MSX-SLOT-3-1-ROM

Created:	2025-11-10
Updated:	2026-01-12
Version:	V1.0
Count:	1

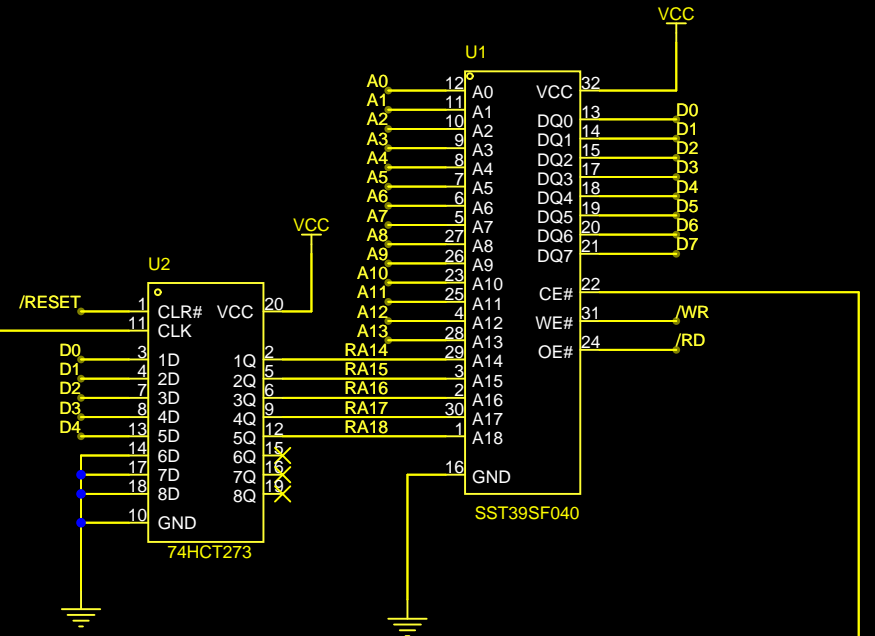
*ADDRESSING ISSUE:

The paging address for the ROM pages are not in the range 7E00-7FF7 as originally intended, due to incorrect mapping of U2 to U3.
